UNITED STATES
ATOMIC ENERGY COMMISSION
WASHINGTON, D.C. 20545

Change No. 24
License No. DPR-6

We have reviewed your Proposed Change No. 24 dated December 21, 1970, to the Technical Specifications of Facility License No. DPR-6 for reactor operation with two new centermelt fuel bundles and five of the original six centermelt fuel bundles.

CHANGE NO. 24 TO TECHNICAL SPECIFICATIONS

FIGURE 8.6 NEW INTERMEDIATE PERFORMANCE FUEL CENTERMELT ASSEMBLY (8x8 ARRAY)

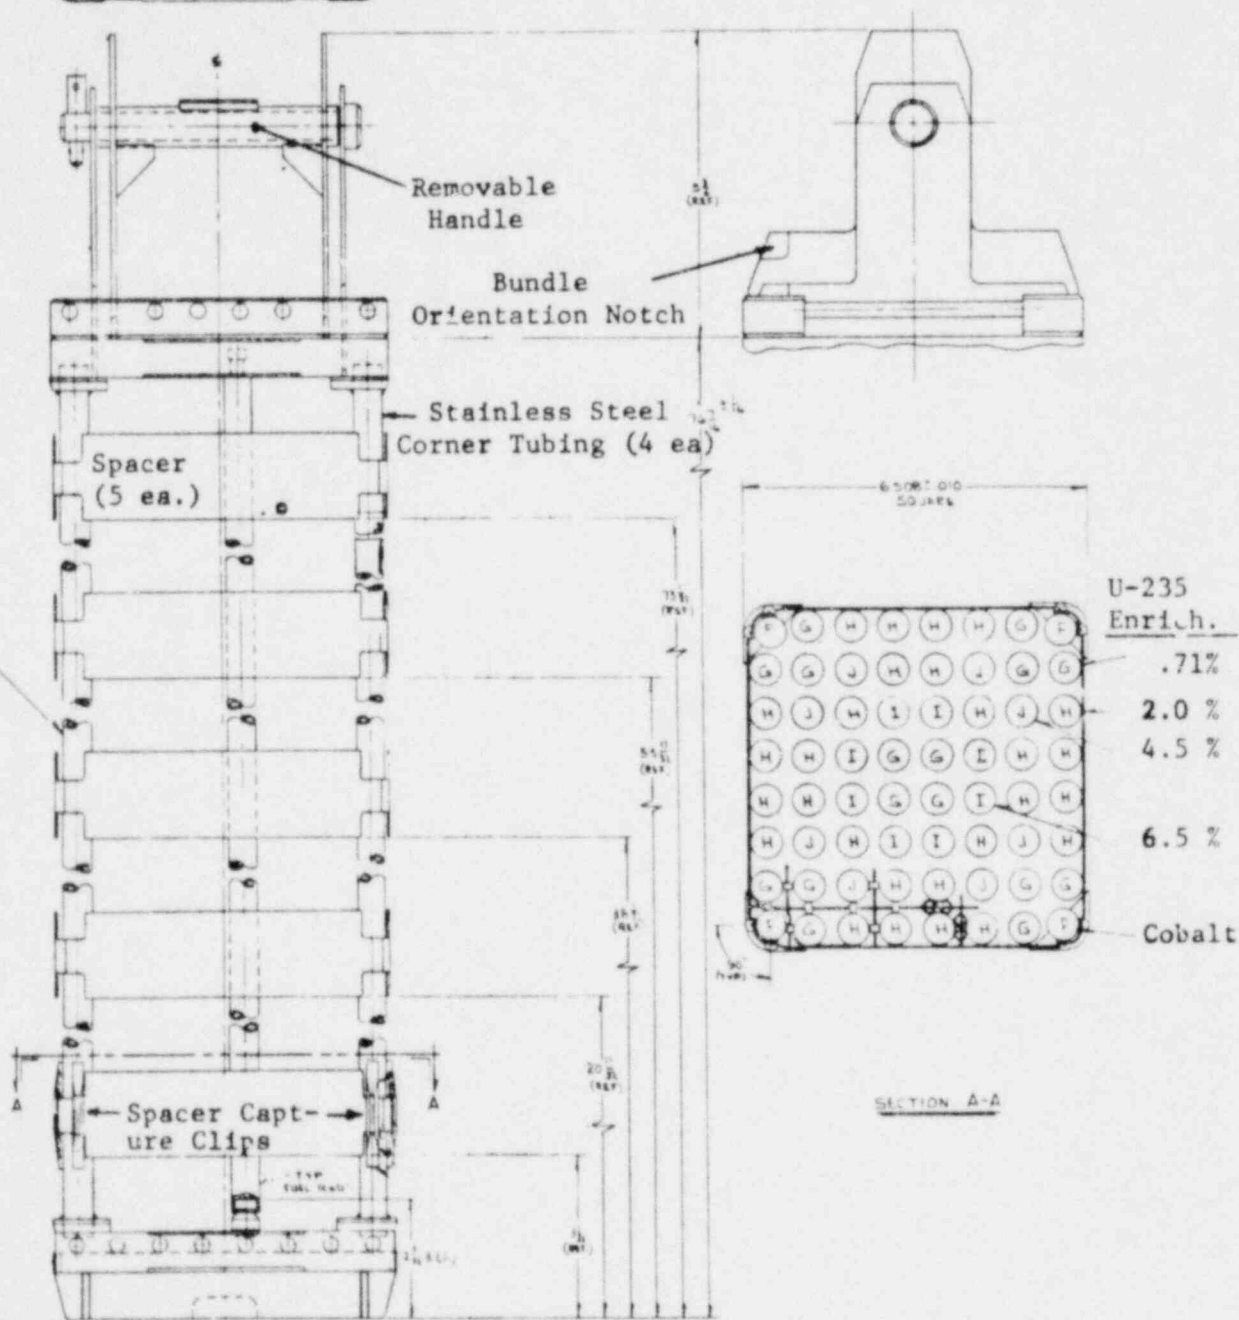
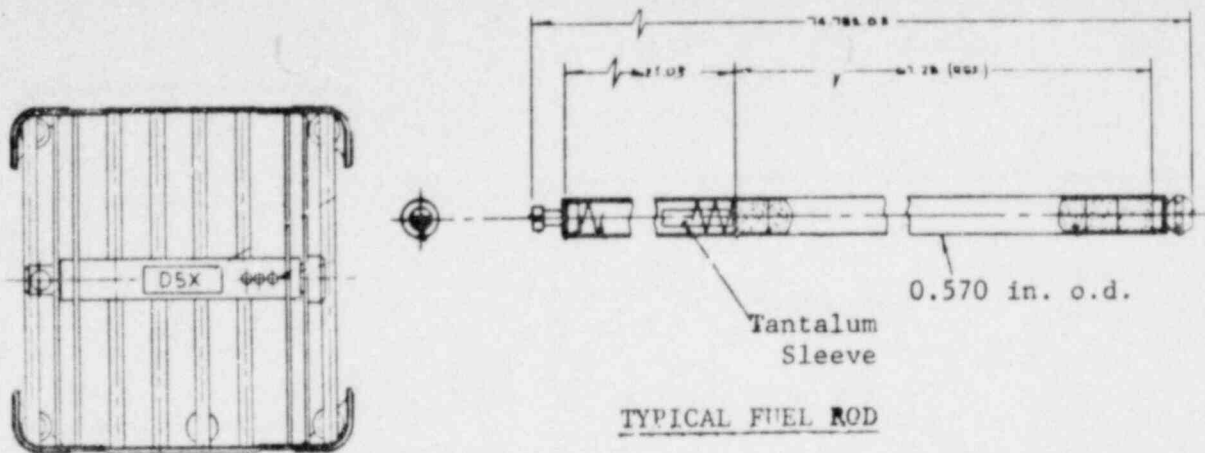
The new centermelt fuel bundles are different from the original centermelt assemblies in the following respects: 1) sheet metal corner angles have been eliminated, 2) removable cobalt targets have been placed in new stainless steel corner tubes, 3) there are fewer (16 compared with 29 and 36) high power fuel rods, and 4) rod-to-rod power gradients have been reduced. Before the five original centermelt fuel assemblies that were irradiated during April, May and June 1967 are returned to the Big Rock Point Nuclear Reactor, the crud accumulated during that irradiation period will be removed by chemical cleaning and eight of the high power rods in the outer rows will be replaced by low power rods. With two new centermelt fuel bundles in the core, there will be a total of 32 high power rods at or near centermelt conditions at rated power. When the five original centermelt fuel assemblies have been reconstituted and reinserted into the Big Rock Point core, the total number of high power rods will be 172 compared with 188 for the six centermelt fuel bundles as originally fabricated and irradiated in the Big Rock Point core in March 1967.

Add Figure 8.6 - New Intermediate Performance Fuel Centermelt Assembly (8 x 8 Array) and Figure 8.7 - New Advanced Performance Fuel Centermelt Assembly (7 x 7 Array).
